Duke Power Company
Oconee Nuclear Station

Proposed Technical Specification Revision

UNIT 1 OCONEE NUCLEAR STATION
 REACTOR COOLANT SYSTEM NORMAL OPERATION-HEATUP
 LIMITATIONS APPLICABLE FOR THE FIRST 15 EFY

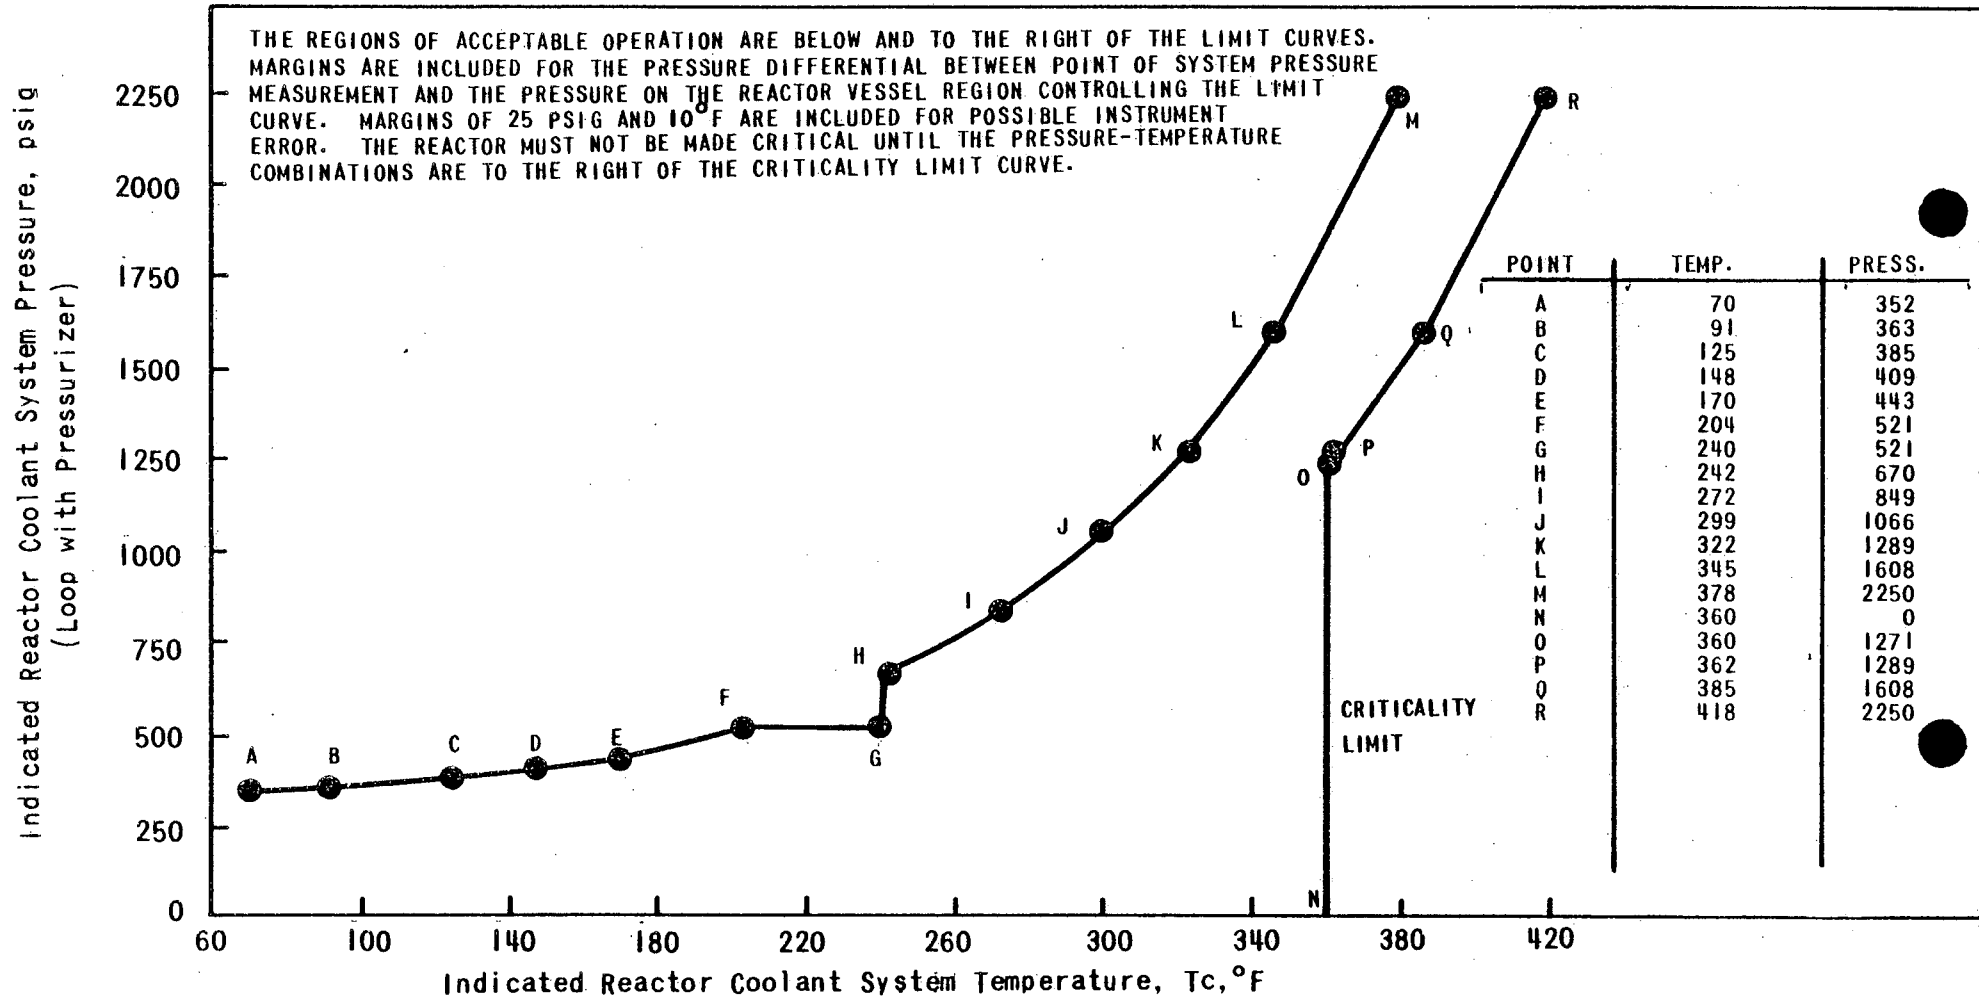
Heatup rates and allowable combinations of pressure and temperature shall be limited in accordance with Table 3.1-1 and Figure

- 3.1.2-1A Unit 1
- 3.1.2-1B Unit 2
- 3.1.2-1C Unit 3

Figure 3.1.2-2A

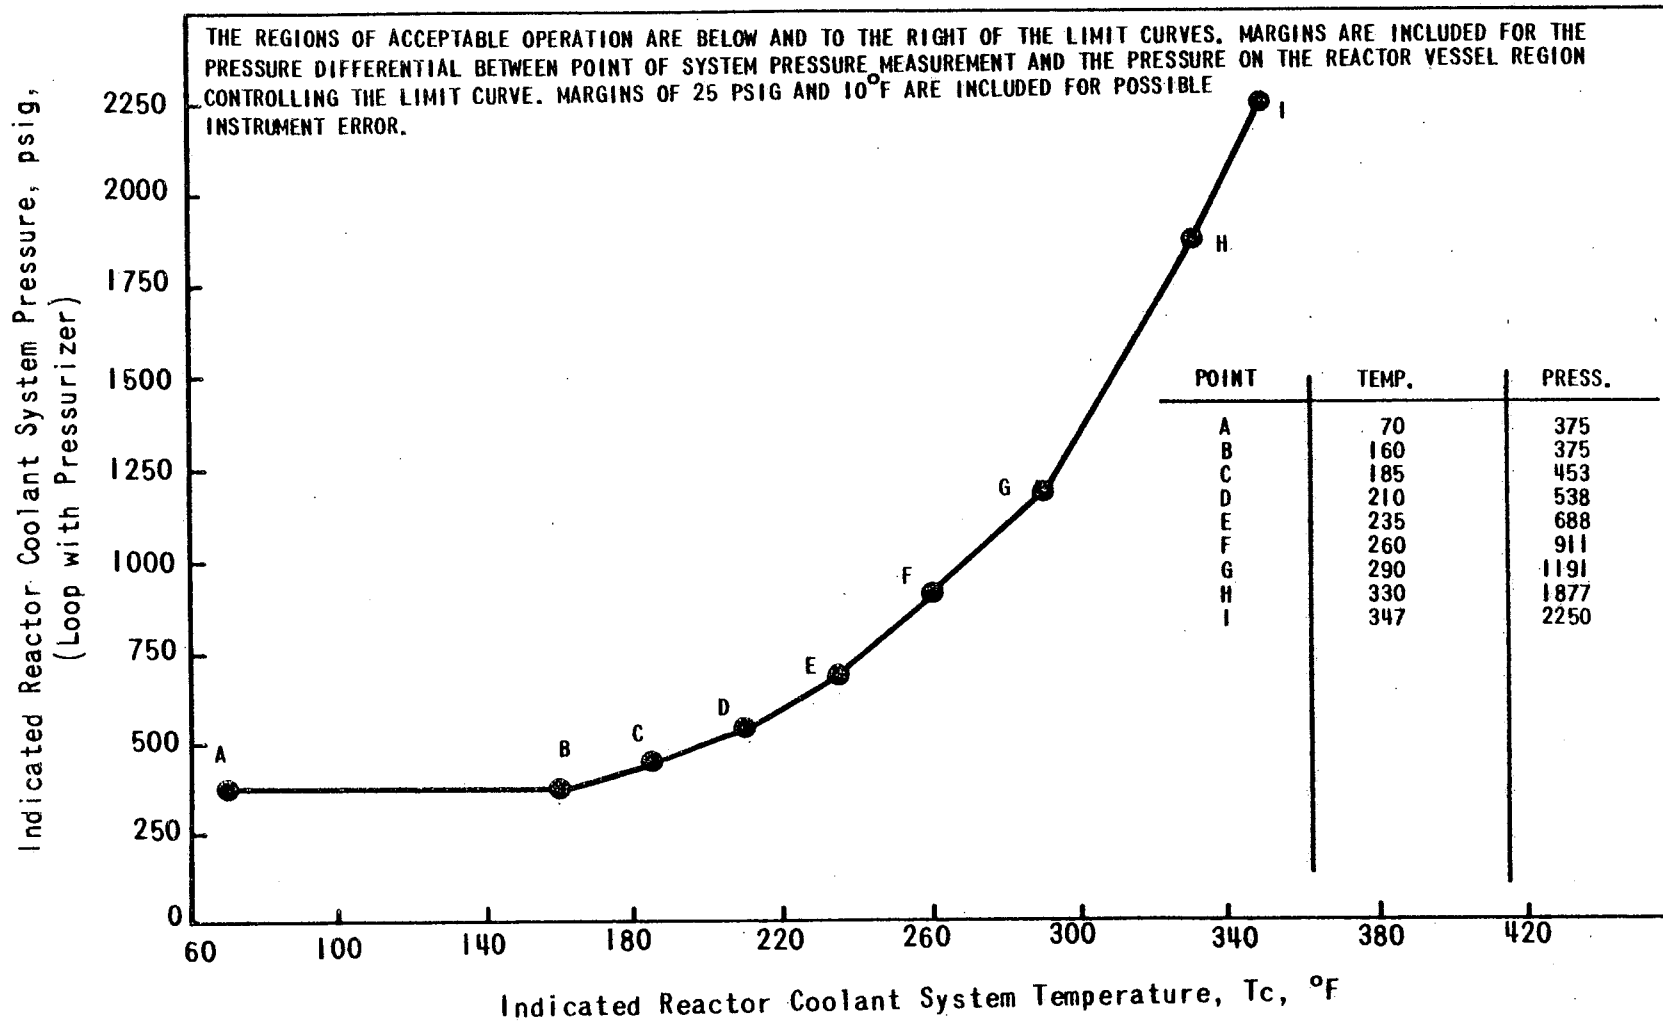
Cooldown rates and allowable combinations of pressure and temperature shall be limited in accordance with Table 3.1-2 and Figure

- 3.1.2-2A Unit 1
- 3.1.2-2B Unit 2
- 3.1.2-2C Unit 3

Figure 3.1.2-3A

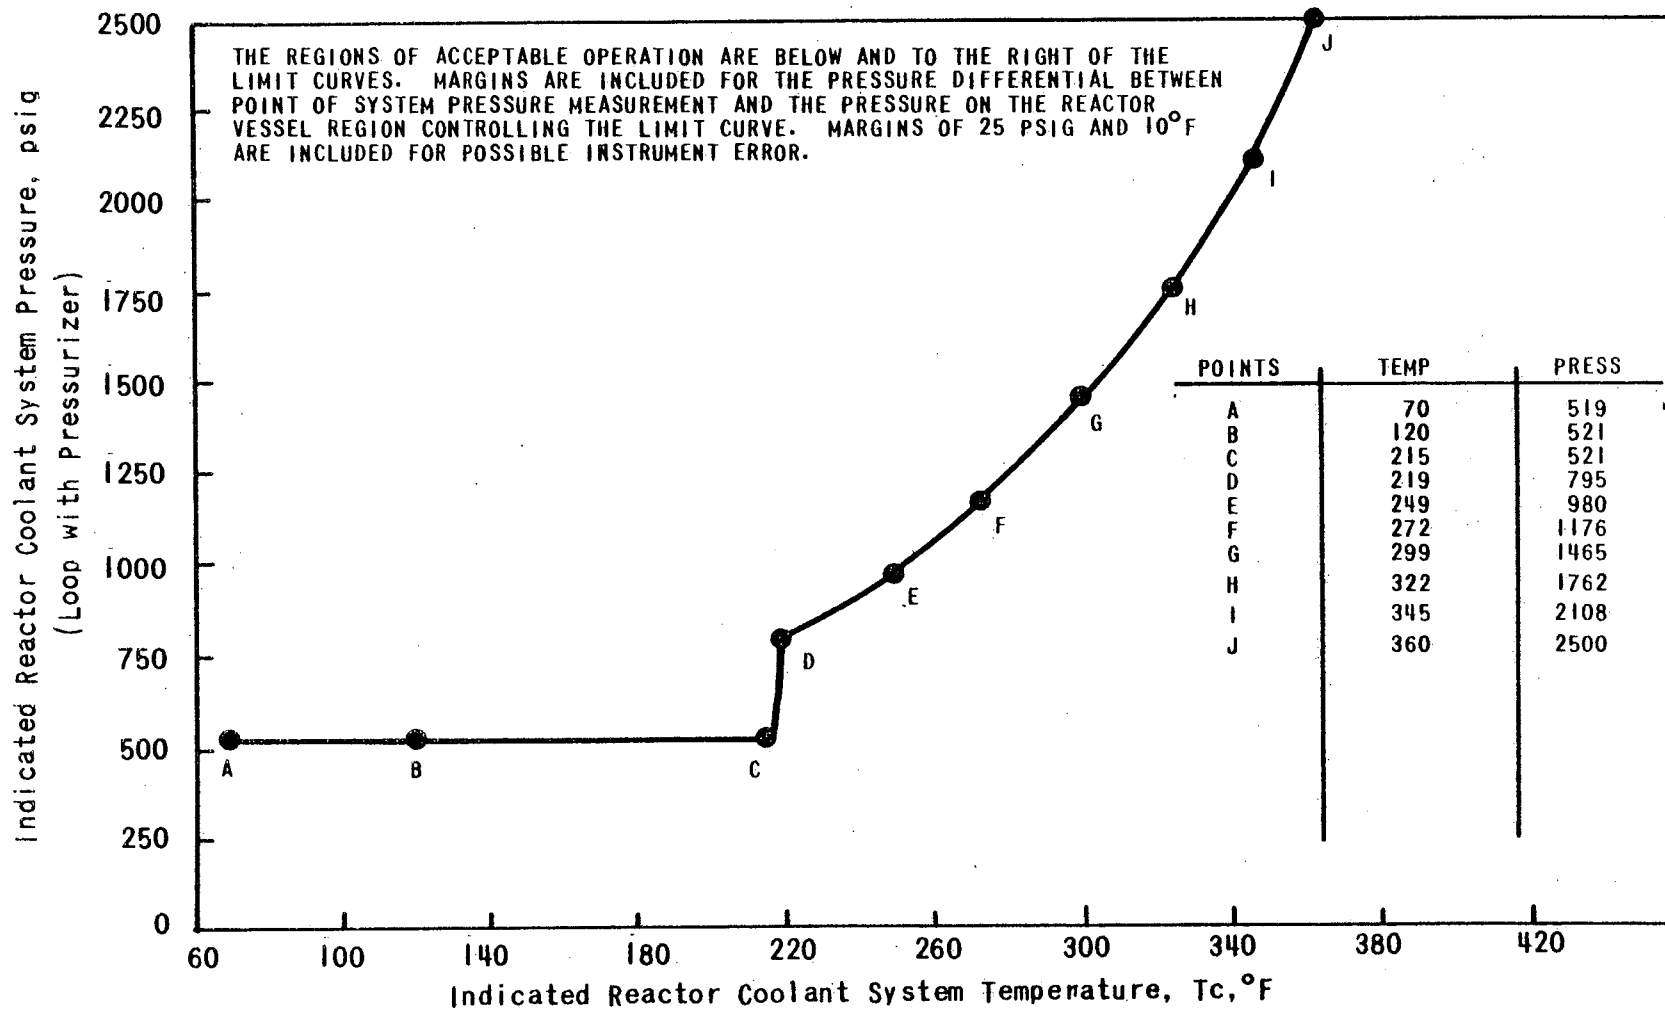
- 3.1.2.2 Leak tests required by Specification 4.3 and ASME Section XI shall be limited to the heatup and cooldown rates and allowable combinations of pressure and temperature provided in Tables 3.1-1, 3.1-2 and Figure 3.1.2-3A Unit 1

Figure 3.1.2-3B

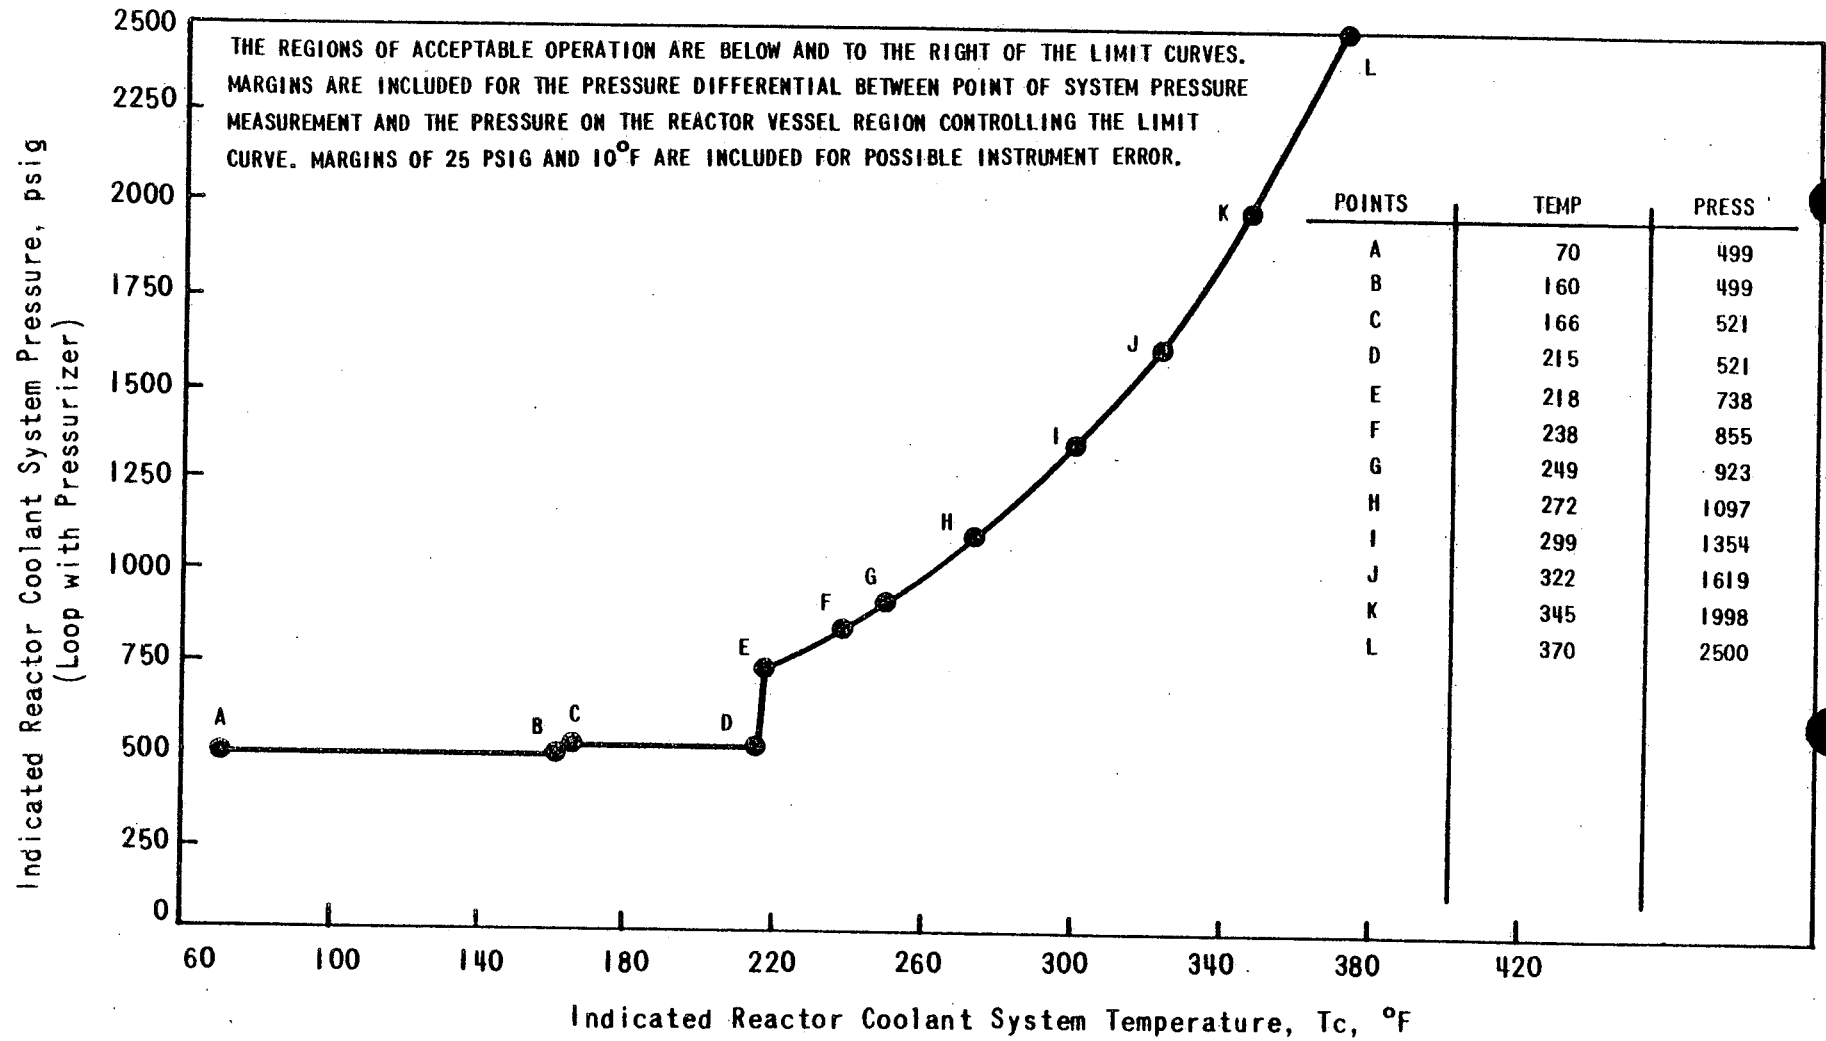
- 3.1.2-3B Unit 2
- 3.1.2-3C Unit 3
